US-APWR DCD Tier 1 Enhancement Project
Thursday 2/17/11 Afternoon Handout No.2
Table of Contents

Tier 1 Changes Explanation/Basis Document
Tier 1, Section 2.7.5.1

Figure 2.7.6.3-1 Spent Fuel Pit Cooling and Purification System

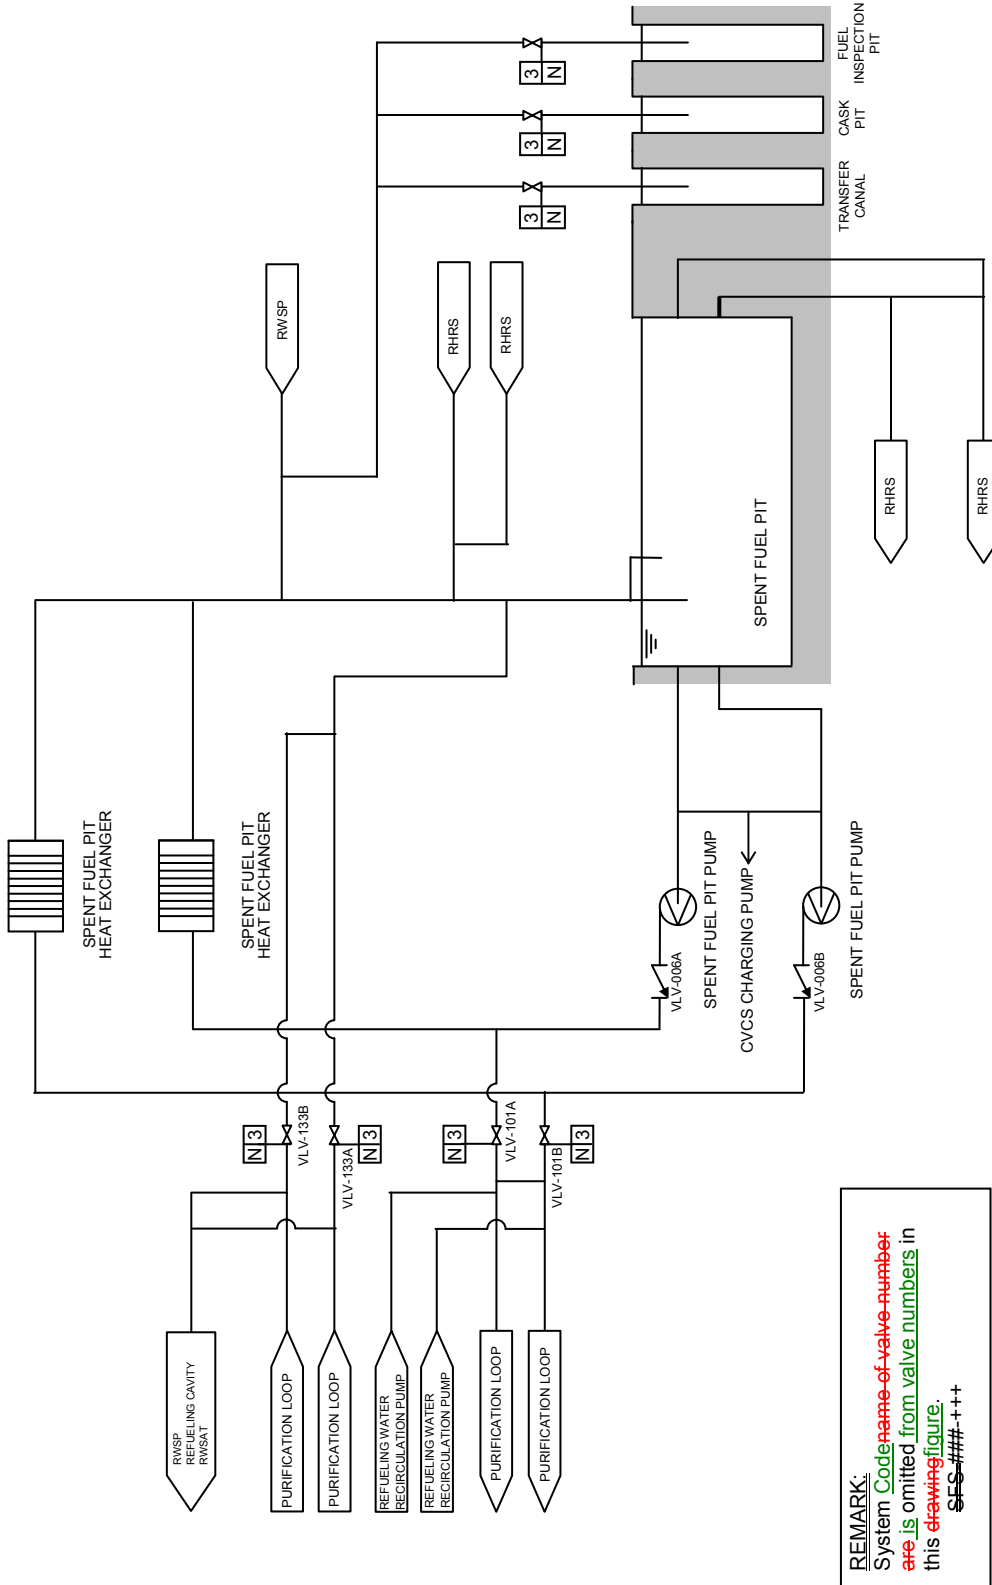
11	DC, ITA, AC – Editorial change to agree with generic format for ITAAC.
12	DC, ITA, AC – Generic changes to ITAAC of check valve active safety function to provide clarity and consistency. [RIS p7, Consistency, second bullet]
Figure 2.7.6.3-1	
Editorial changes to remarks.

Figure 2.7.6.7-1 Process and Post-accident Sampling System

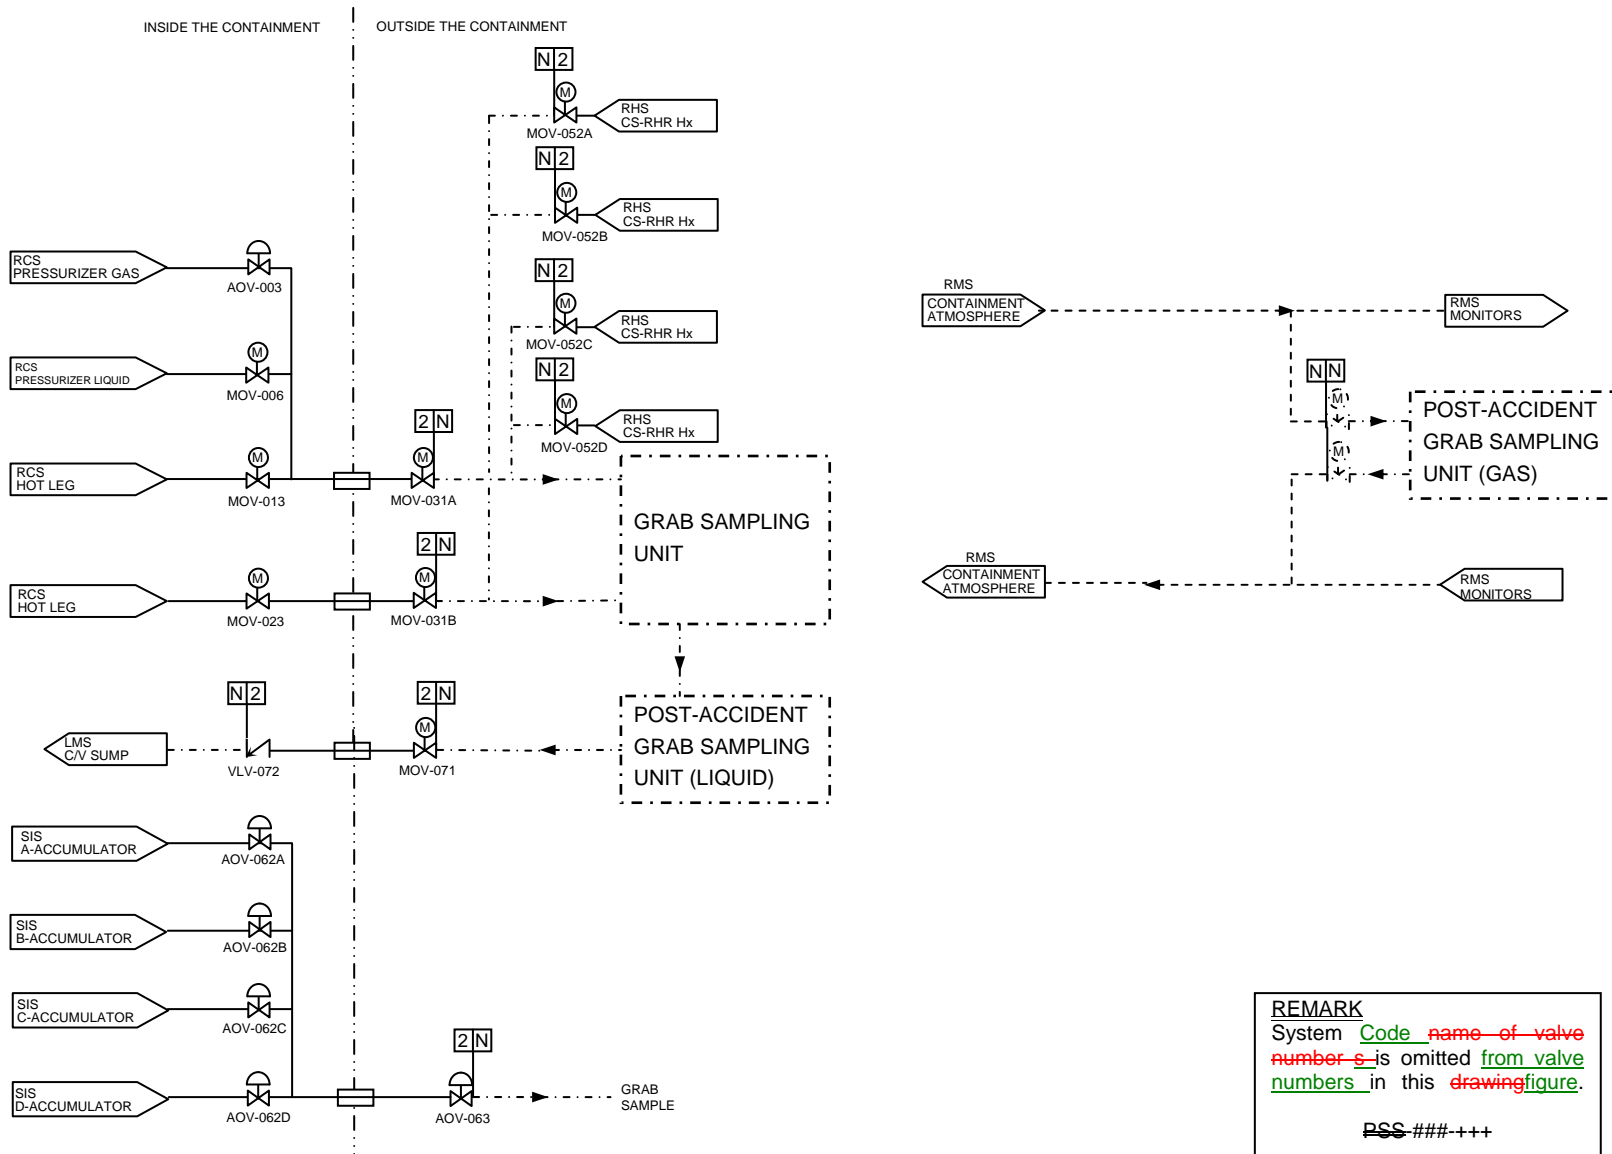
13.ii	<p>ITA, AC: Generic changes made to ITAAC for RSC alarms, displays and controls operability to provide clarity and consistency. [RIS R1, p7, Standardization and Consistency, 2nd bullet]</p> <p>This change alters the changes made in UAP-HF-10043.</p>
Figure 2.7.6.7-1 Process and Post-accident Sampling System	
REMARK Revised to correct grammar and changed system “name” to “Code” and “drawing” to “figure” for consistency.	
The non-safety related portion is in dash dot line to be consistent with Figure symbol defined in Tier 1 Section 1.3.

Figure 2.7.6.8-1 Equipment and Floor Drain System Flow Schematic

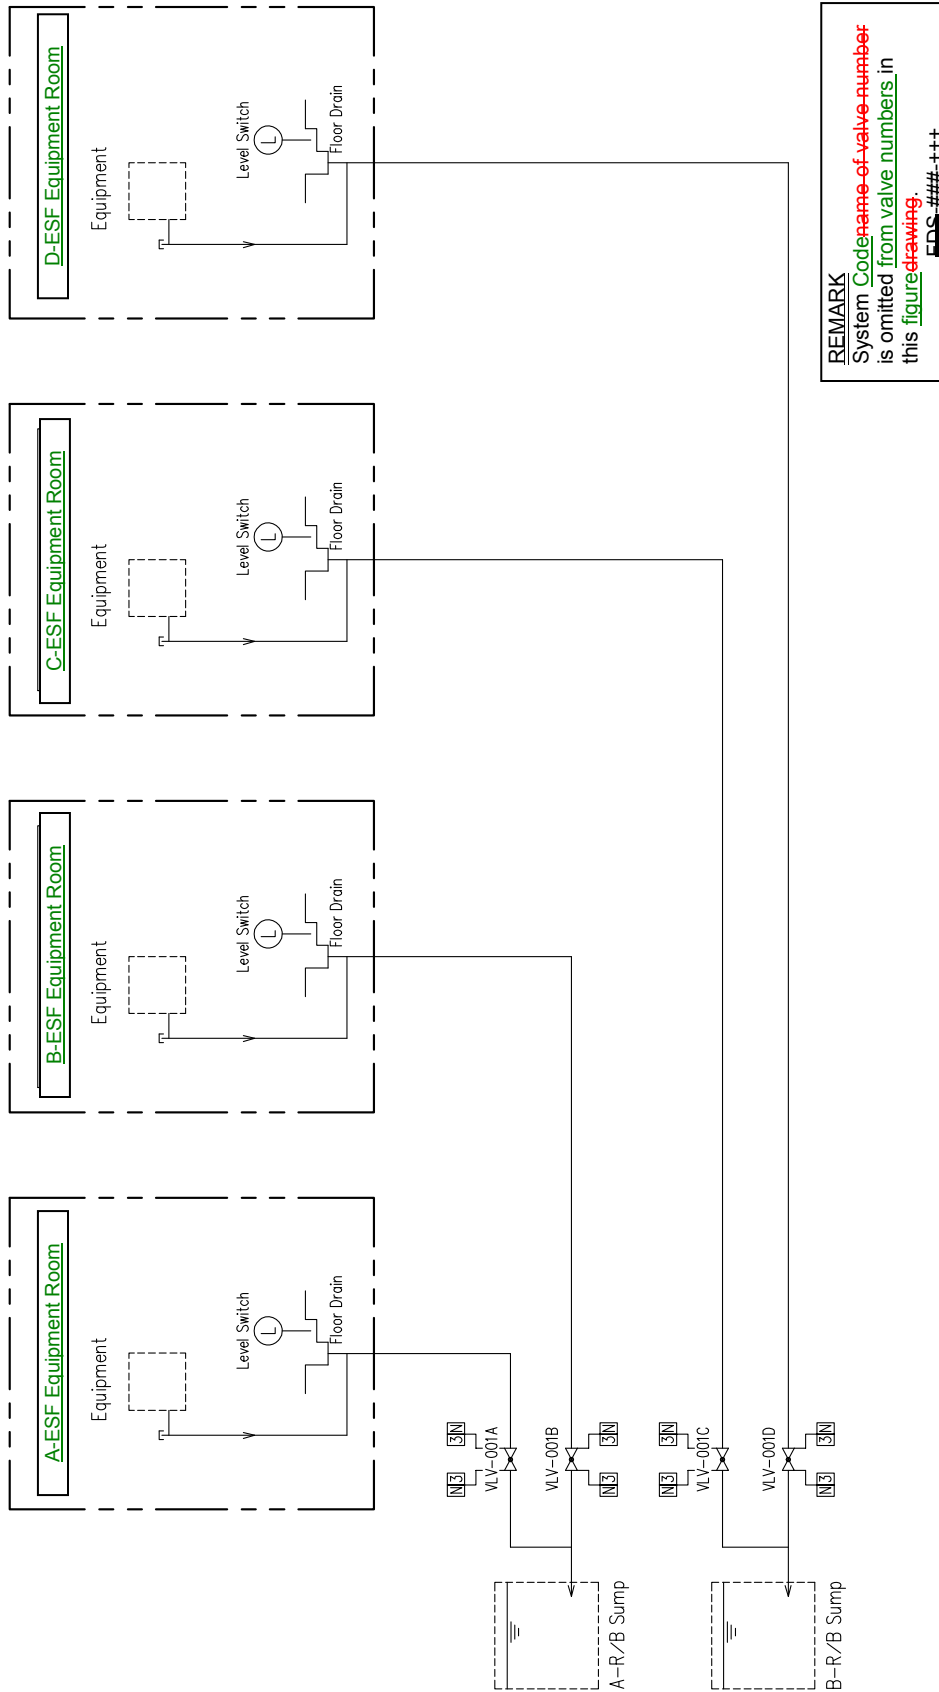
5.a	<p>DC, ITA and AC</p> <ul style="list-style-type: none"> – ITAAC is deleted. The drain isolation valves from the ESF equipment rooms identified in Figure 2.7.6.8-1 are manual valves, not remotely operated valves. [RIS – Standardization & Consistency, 4th bullet.] This change alters the response to RAI 242, Revision 0, 14.03.03-16.
